UNITED STATES
NUCLEAR REGULATORY COMMISSION
WASHINGTON, D. C. 20555

SAFETY EVALUATION BY THE
OFFICE OF NUCLEAR REACTOR REGULATION RELATED TO
INSPECTION AND REPAIRS OF HATCH UNIT 1
PRIMARY SYSTEM PIPING AND CORE SPRAY SPARGERS

Figure 1-1a. Plan View of Cracked Core Spray Sparger

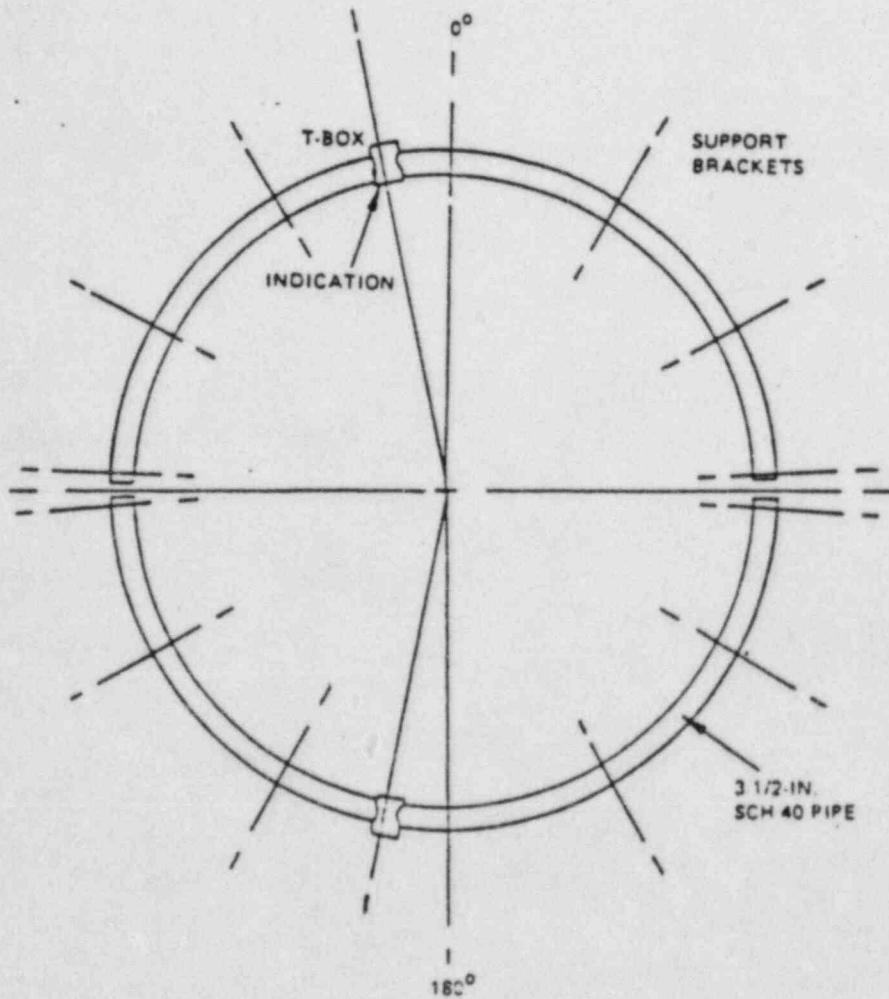
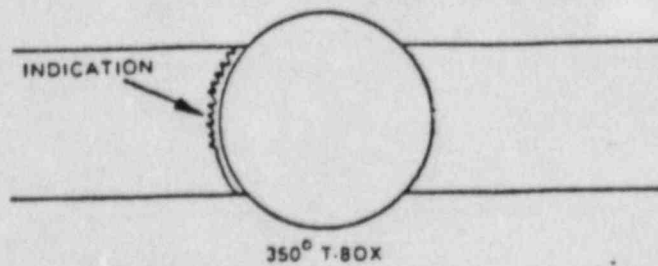
During this refueling/maintenance outage, the licensee also performed a visual examination of the core spray spargers in accordance with I&E Bulletin 80-13. The results of the visual examination revealed cracking of the lower sparger arm near the 350 degree T-box. The cracks were oriented in the circumferential direction and were located in the heat-affected zone of the sparger to T-box weld, approximately 1/8 inch from the weld. The cracks spanned at least 180 degrees of the pipe circumference with a maximum of 1.010 inch in width (Figure 1).

The staff has reviewed the licensee's analysis and the repair of the cracked core spray sparger. Although the staff may not completely agree with the conclusions of the licensee's analysis, the repair methodology (using clamping devices on cracked spargers) is consistent with the applied at other plants, and approved by the staff. At Oyster Creek and Pilgrim Plants, visual examinations were performed on cracked core spray spargers in successive refueling outages and no significant progression of the cracks were reported. Therefore, based on the field experiences at other plants, the cracks in the core spray sparger are not expected to grow to any significant extent during the next fuel cycle. The staff concludes that the repaired core spray sparger

For added safety margin, the licensee elected to install a clamping device (C-clamp) which gripped the sparger with a pair of fingers on each side of the T-box to limit the relative movement of the two sections of the sparger. The clamp assembly was fabricated from type 304L austenitic stainless steel with a maximum carbon content of 0.02 weight percent.

is acceptable for continued operation of one fuel cycle of 18 months. Continued operation of the repaired core spray sparger beyond the next fuel cycle will depend on the evaluation of the inspection results performed during the next refueling outage and the continued effectiveness of the clamping device applied to the cracked sparger.

Figure 2 Hatch Unit 1 DBA (Limiting LOCA) Analysis

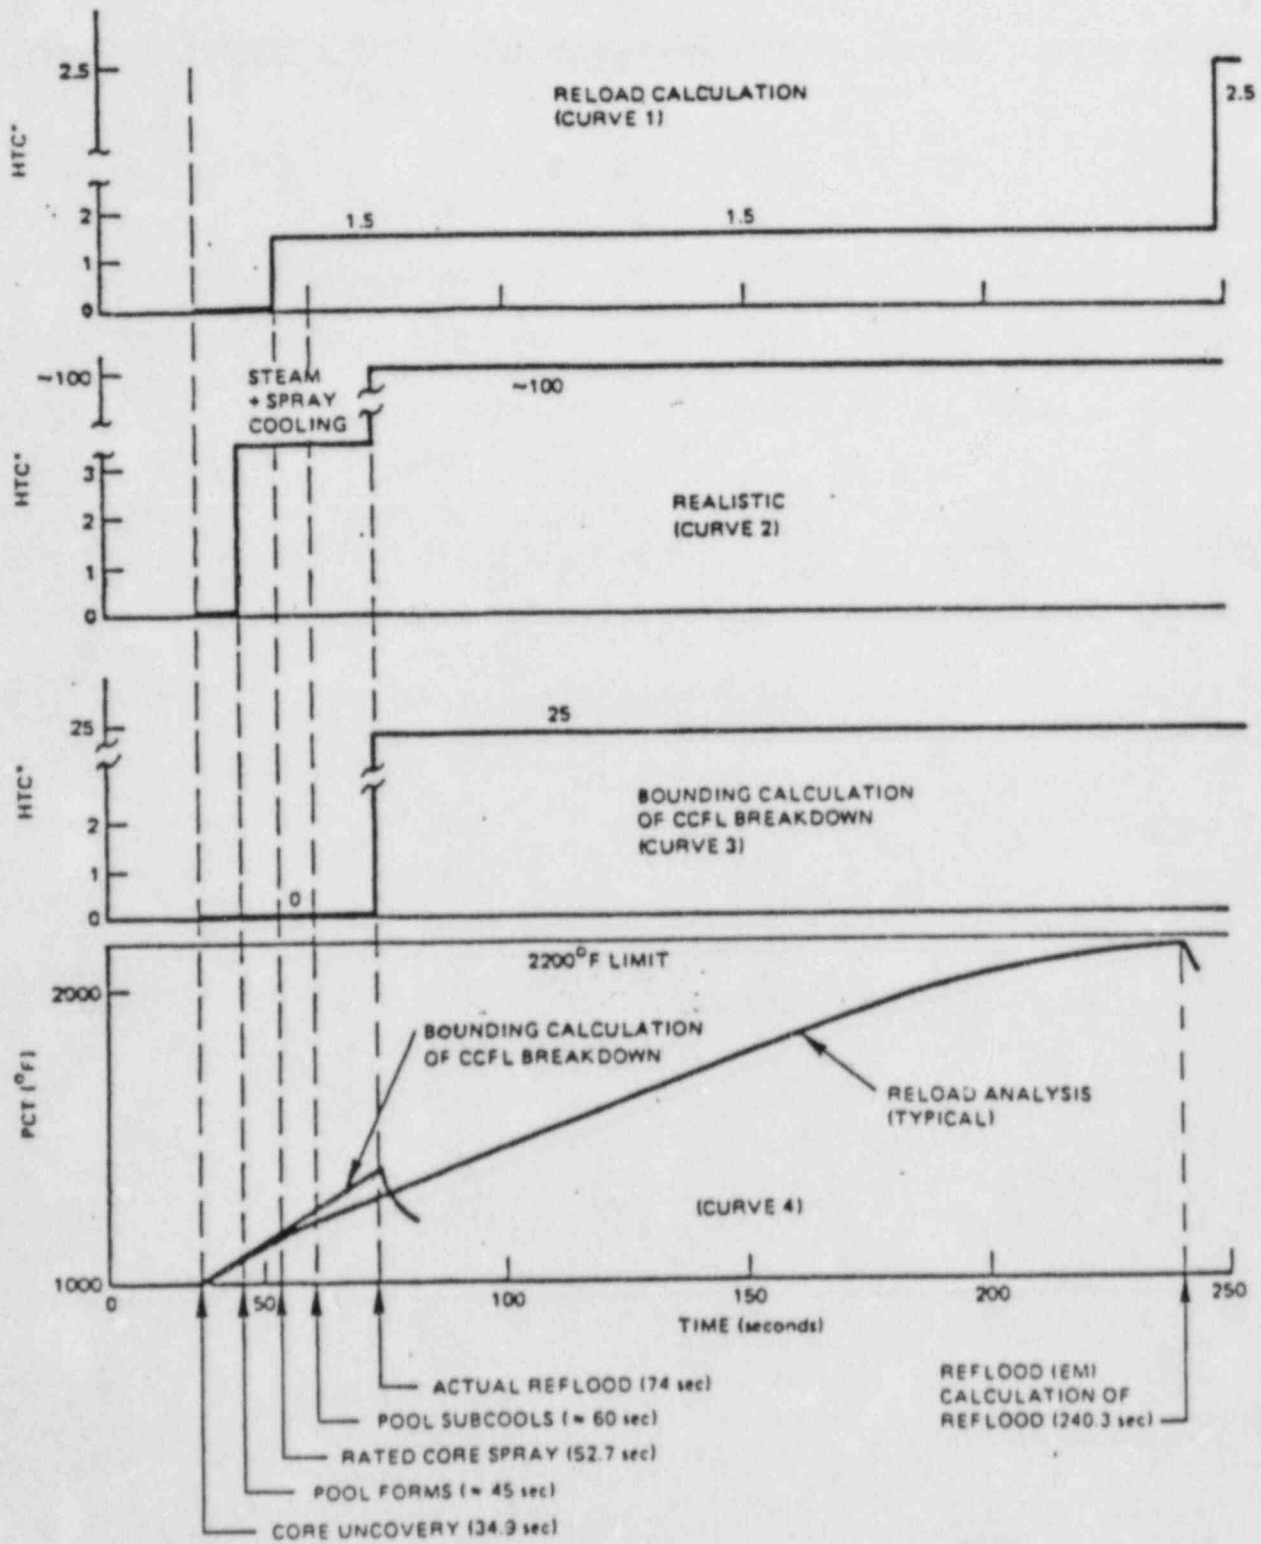
GE ECCS analysis indicates that for a core spray line break, there are always at least three low pressure ECCS pumps injecting water into the reactor vessel. It ensures that this break is not a limiting event. The plant specific LOCA analysis based on the SAFE and REFLOOD Codes indicates that a suction line break in the recirculation line with a LPCI injection valve failure is the most limiting break by a large margin. This limiting LOCA analysis was performed with the conservative modeling of counter current flow limits (CCFL) at the fuel assembly upper tie plates. The calculation limits the coolant delivery or downflow from the core spray systems to the fuel bundles. Further it delays core reflooding by neglecting the water held back in the upper plenum. The Peak Cladding Temperature (PCT) using this model did not exceed 10 CFR 50.46 temperature limit of 2200° F (Figure 2, curve 4).

GE Lynn facility large scale tests show that core spray flow injected into the upper plenum drains to peripheral bundles and increases the bottom reflood rate. GE performed a bounding calculation of the limiting LOCA case with CCFS breakdown input. No credit was taken for the spray cooling effect (i.e., the heat transfer coefficient for spray cooling is assumed to be zero). The calculated PCT is about 1380°F. This result demonstrates that the current reload analysis calculation of PCT is conservative (Figure 2, curve 4).

We find this acceptable and conclude that the cooling function of the core spray system would not be degraded.
